NEL-99-0272

Joseph M. Farley Nuclear Plant Response to Requests for Additional Information – Beyond Scope Issue, Chapter 3.5 Revised Responses to Requests for Additional Information Related to Conversion to the Improved Technical Specifications – Chapters 3.6 and 3.8

SNC Responses to Beyond Scope Questions for Chapter 3.5 and Revised Responses to NRC Requests for Additional Information Related to Conversion to the Improved Technical Specifications Chapters 3.6 and 3.8 Chapter 3.5

ARE 3.8.5-01 Revised Response FNP SPECIFIC 3.8.5 DC SOURCES-SHUTDOWN LCO SECTION OF BASES

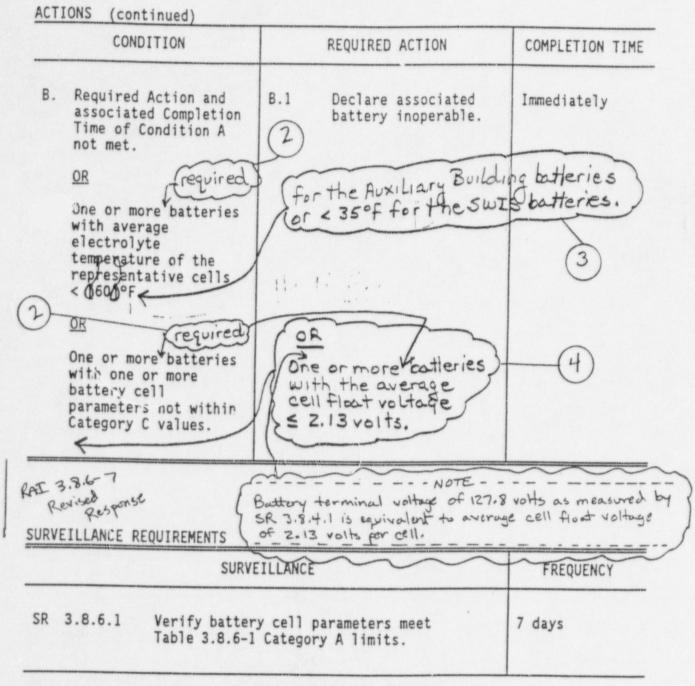
3.8.5-01 ITS LCO 3.8.5 CTS LCO 3.8.2.4 DOC 1M

Comment: Some revision to the LCO appears to be required. When making revision, consideration should also be given to the fact that, in some circumstances, more than one Aux. Bldg., DC power subsystem may be required in Modes 5 and 6. Also "DC electrical power subsystem" should be corrected to read "DC electrical power subsystem(s)"

Additional Comment: Insert SS should be revised to clearly state "one train of Auxiliary Building DC and one train of SW DC consisting of..."

Insert SS to the ITS LCO Bases Section 3.8.5 has been revised to clearly delineate that at least one train of Auxiliary Building and SWIS DC distribution are required operable during shutdown based on the additional NRC comment. The associated package changes are included in Attachment II.

The DC electrical power sources required to support the necessary portions of AC, DC, and AC vital bus electrical power distribution subsystems required by LCO 3.8.10, "Distribution Systems - Shutdown," shall be OPERABLE. At a minimum, at least one train of DC electrical power source from the Auxiliary Building (Train A or B) and Service Water Intake Structure (Train A or B) consisting of one battery, one battery charger, and the corresponding control equipment and interconnecting cabling within the train, is required operable.

In the case where the requirements of LCO 3.8.10 call for portions of a second train of the distribution subsystems to be OPERABLE (e.g., to support two trains of RHR, two trains of CREFS, or instrumentation such as source range indication, containment purge and exhaust isolation actuation, or CREFS actuation), the required DC buses associated with the second train of distribution systems are OPERABLE if energized to the proper voltage from either:

- An OPERABLE DC Source consisting of one battery, one battery charger, and the corresponding control equipment and interconnecting cabling associated with that train, or
- a battery charger using the corresponding control equipment and interconnecting cabling within the train.
